# Technical News

**SAILOR**

NUMMER 3

FEBRUAR 1995

## TILSLUTNING AF R2120 TIL T2130 UDEN N2165 I INSTALLATIONER MED KONSOL H2192.

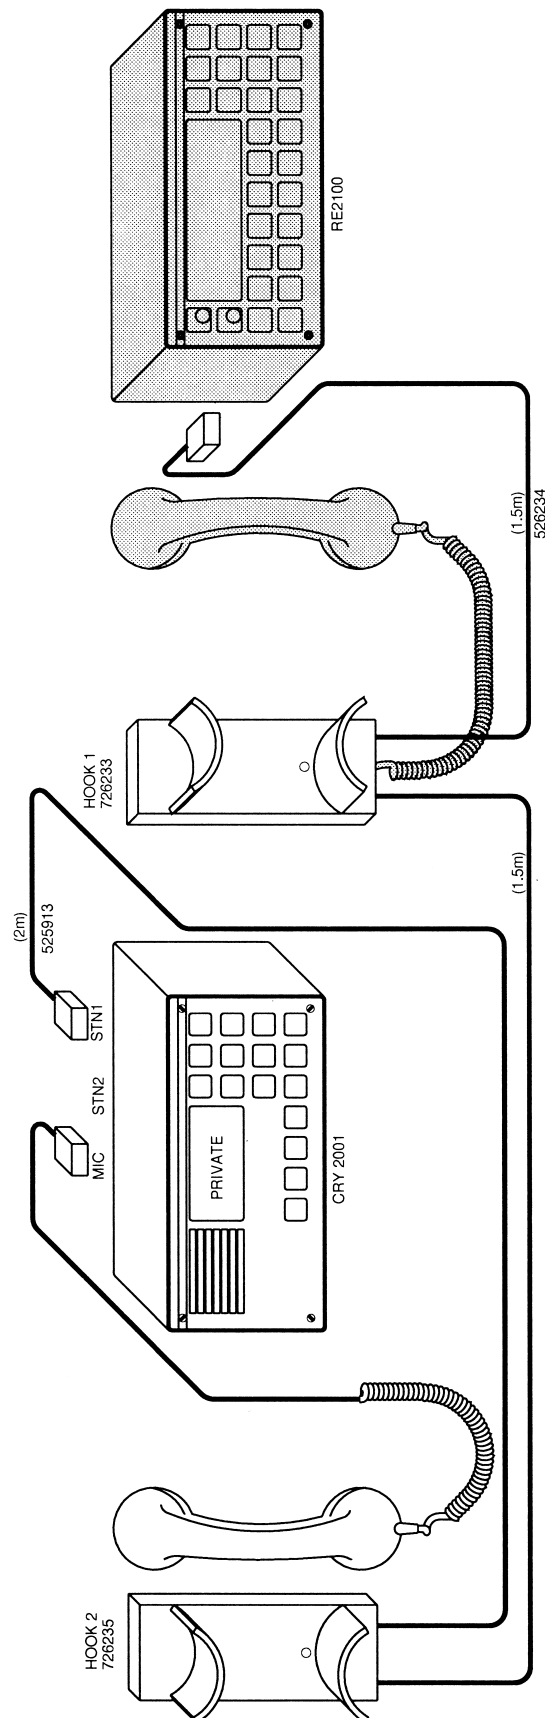
Der er også information om, hvordan der kan spares en N2165 strømforsyning, hvis duplex modtageren R2120 installeres sammen med en H2192 konsol.

R2120	T2130	COLOUR	SIGNAL
J1-5	ST2		
1	1	SORT	RX MUTE
2	<b>ST7-10</b>	BRUN	GROUND
10	14	BLÅ	-18V
11	3	VIOLET	+9V
12	4	GRÅ	+18V
15	2	BRUN/GUL	VF/AE CURRENT
17	12	BRUN/PINK	0dBm OUT
18	9	HVID/PINK	0dBm OUT
19	11	HVID/GUL	EXT.RF CONTROL
21	13	HVID/BLÅ	TX-KEY
24	4	GRÅ/PINK	+18V

#### MODIFICATION OF CRY2001

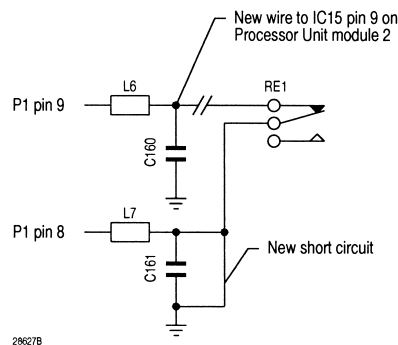
It is necessary to modify the CRY2001 to avoid the RE2100 from going in HF OCC mode, when the Scrambler handset is removed from the hook and STN2 is selected.

This modification must always be carried out, regardless of you have to connect a VHF or not.

This modification has to be carried out on STN1. Therefore you have to connect your RE2100 or C2140 to STN1 and your VHF to STN2.

- A: Disassemble CRY2001 as described in chapter 6.0.
- B: Remove the F&T unit module (1).
- C: Locate the coil L6 and the relay RE1.
- D: Cut the wire on the PCB (component side) between RE1 and L6.

- E: Solder a wire from the conjunction of L6/C160 to IC15 pin 9 on the Processor Unit module 2.
- F: Solder a wire from the conjunction of L7/C161 to ground (across the C161) so that P1 pin 8 is grounded.
- G: Reassemble the CRY2001, connect all cables and perform a function check on all units.

After the modification, the CRY2001 will supply 7.5V out on P1 (STN1) pin 9, when STN2 is selected. This will drive Q1 in the hook on STN2 in saturation and thus prevent RE2100/C2140 from going into HF OCC mode.

## DC STRØMFORSYNING FOR H1252B

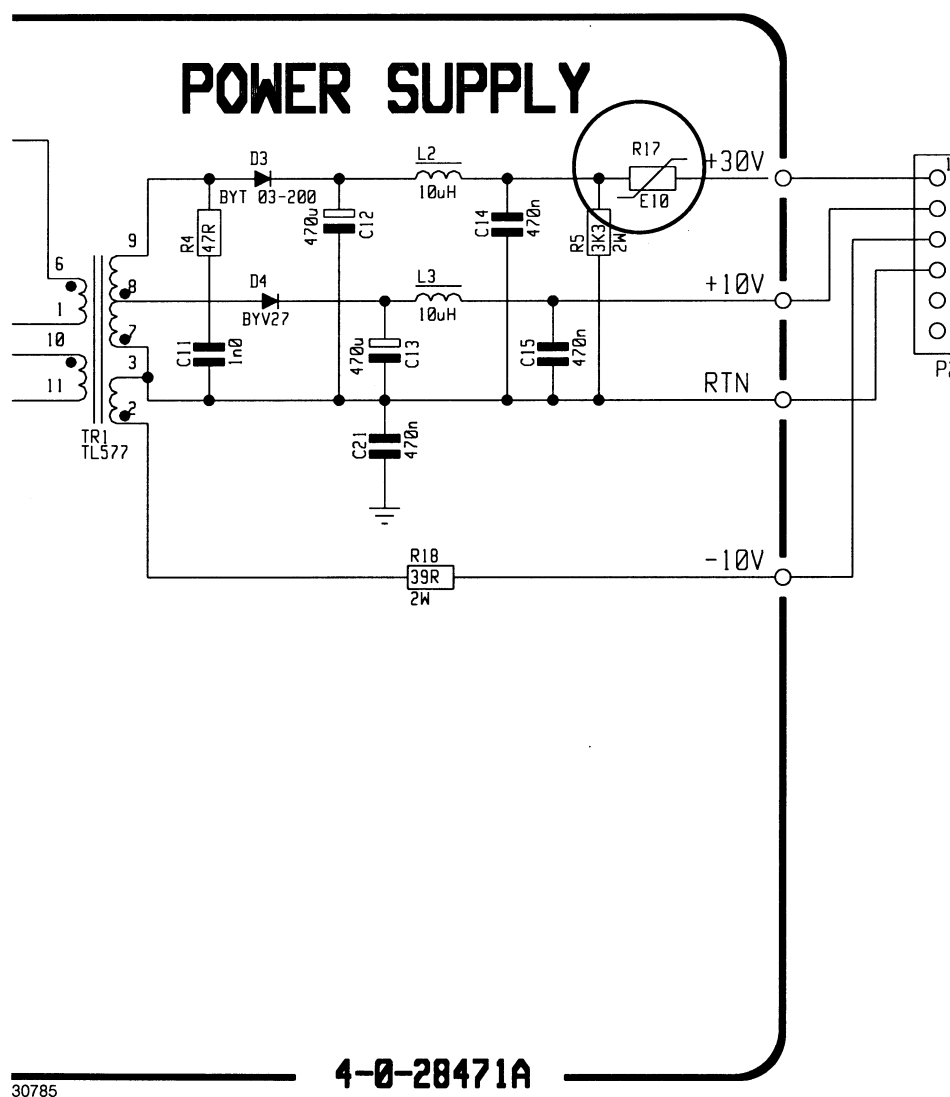
Det er konstateret en forøget fejlfrekvens på DC printere med strømforsyningen (SP nr. 628471), som er vist på vedlagte side, tegning nr. 4-0-28471. Tegningsnummeret findes også på printet.

Fejlen viser sig ved, at dioden D3 kortslutter.

Gentagne fejl undgået ved at montere en autosikring (SP nr. 07162), som vist på vedlagte diagram og printtegning. Autosikringen er en PTC modstand fra Bourns (MR-R-110).

Ved printere med ovennævnte strømforsyning skal kortslutningen over D28 (D10) fjernes, idet denne kortslutning kan forårsage afbrænding af dioden D3 på DC strømforsynings printet.

CONVERTER CONTROLLER MODULE 3

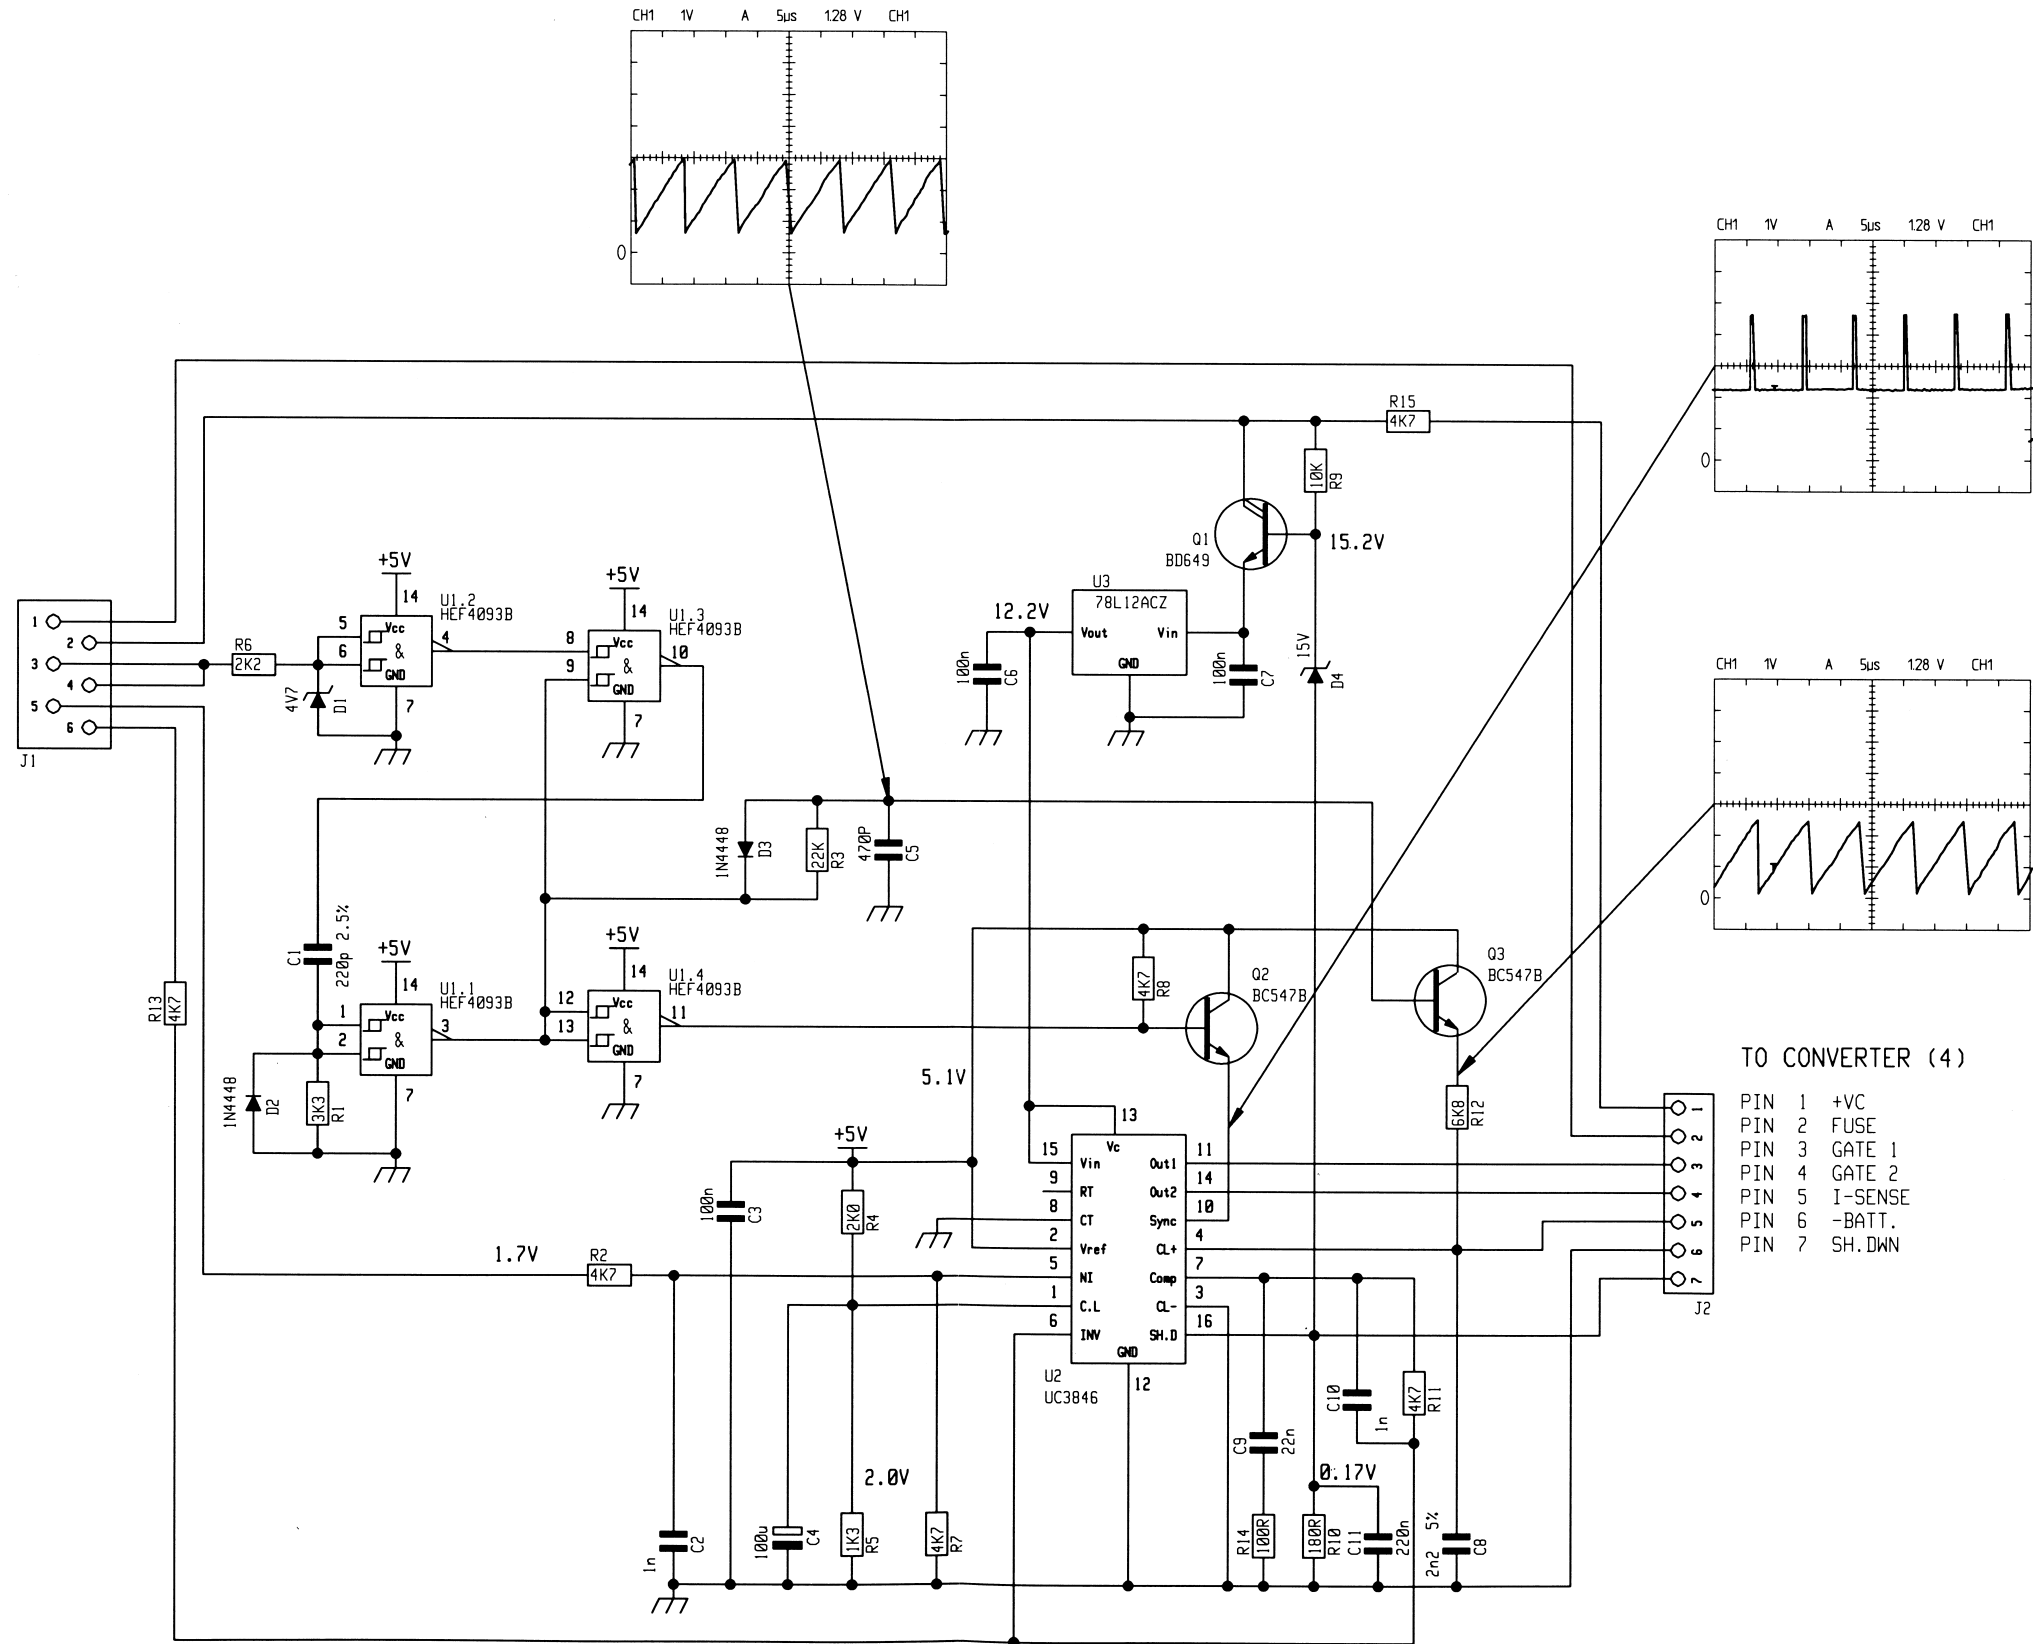
Det har vist sig, at enkelte strømforsyninger N2170 ikke starter ved aktivering, samt at enkelte N2170 ikke leverer fuld effekt.

Årsagen til begge fejl kan være støj på inputspændingen til sense indgangen på U2 på converter controller modulet.

Fejlen afhjælpes ved at montere en 220 nf. kondensator over R10, som vist på vedlagte diagram og printtegning.

# COMPONENT LOCATION TX PROCESSOR MODULE 8

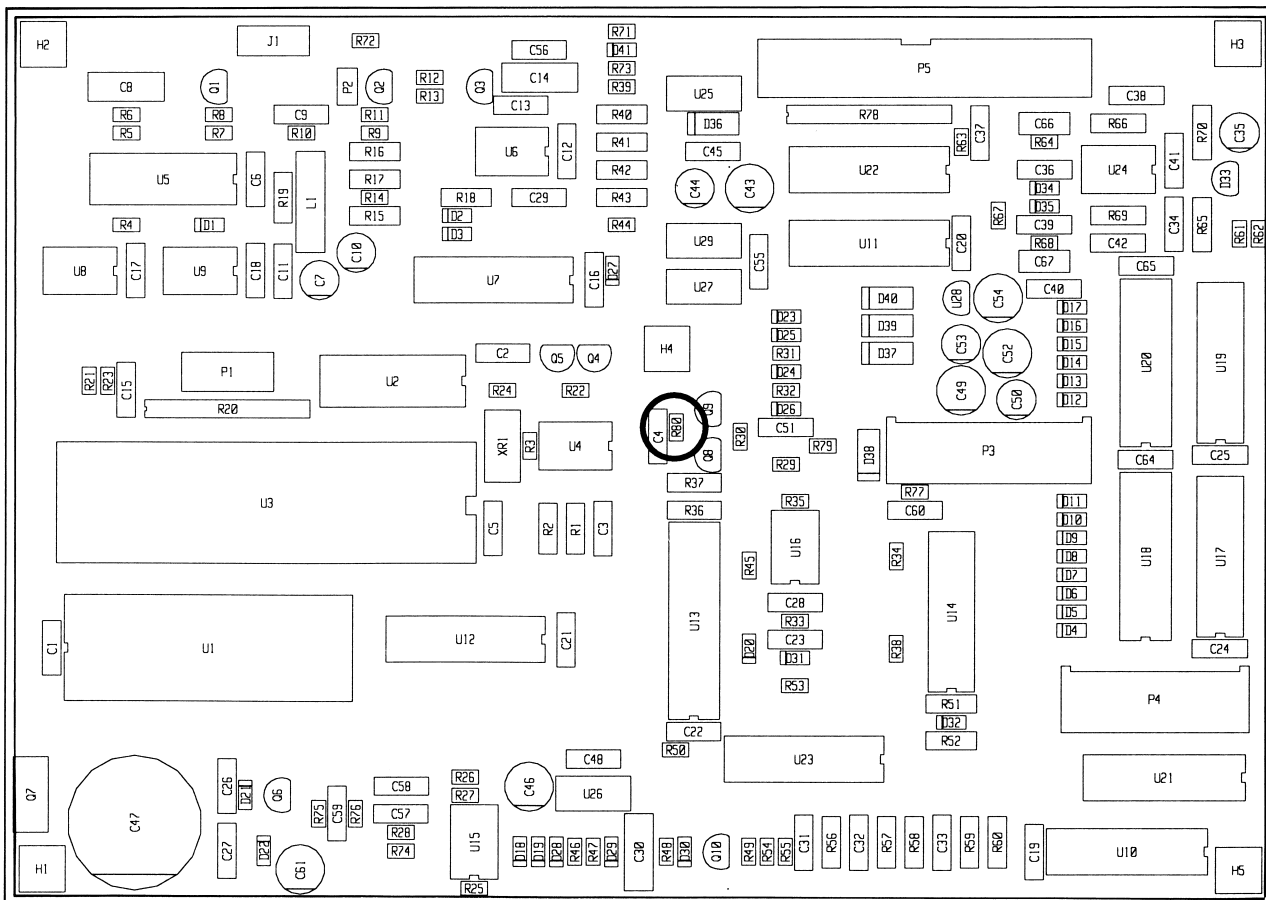
På TX-Processor board modul 8 er modstanden R80 ændret til 100 Ohm. Dette medfører, at TX-Processor modul 8 version 626408EH kun kan anvendes sammen med connection board modul 14 version "N" eller højere.

På TX-Processor board modul 8 er modstanden R80 ændret til 100 Ohm. Dette medfører, at TX-Processor modul 8 version 626408EH kun kan anvendes sammen med connection board modul 14 version "N" eller højere.

### CONNECTION BOARD MODULE 14

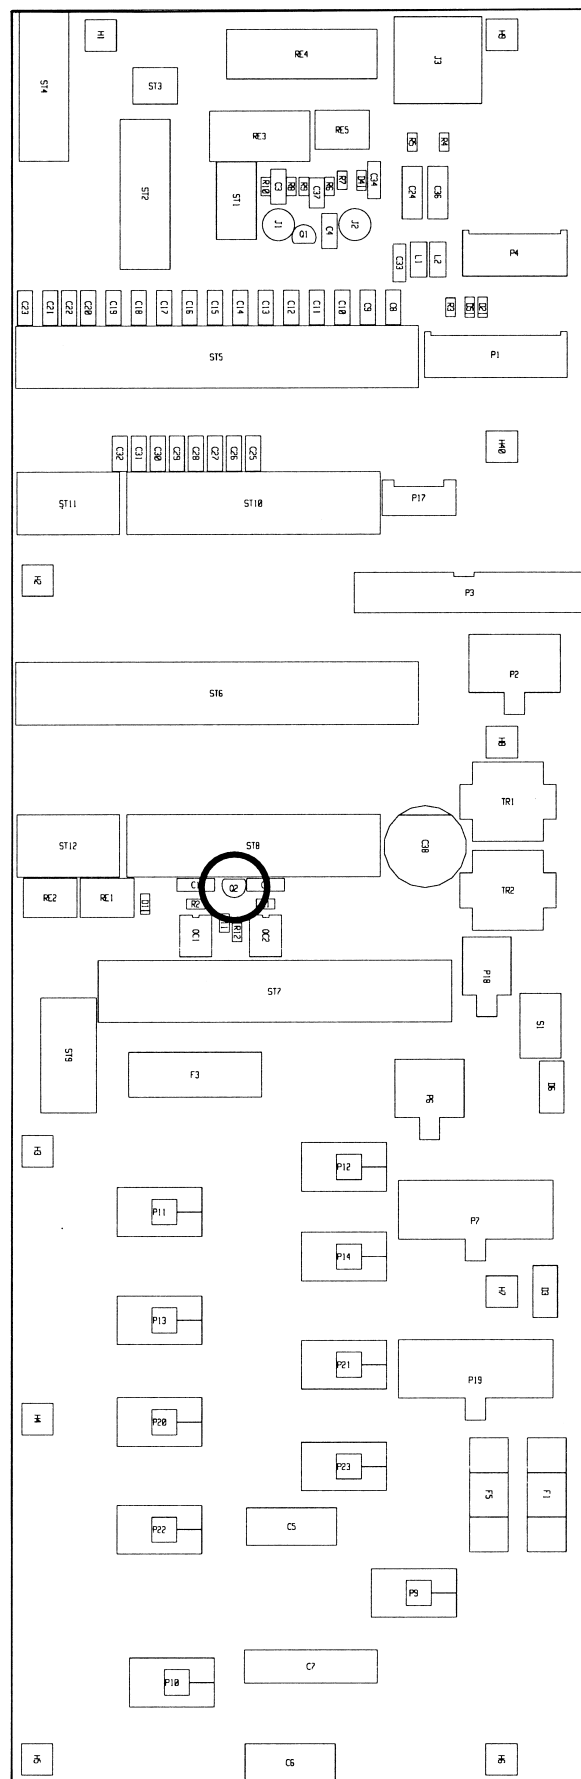
På connection board modul 14 er der indført en transistor Q2 ved OC2, således at dette kredsløb kan trække mere strøm. Moduler med denne ændring har version "N" eller højere. Denne nye version af connection board 14 kan anvendes sammen med alle versioner af TX-Processor modul 8.
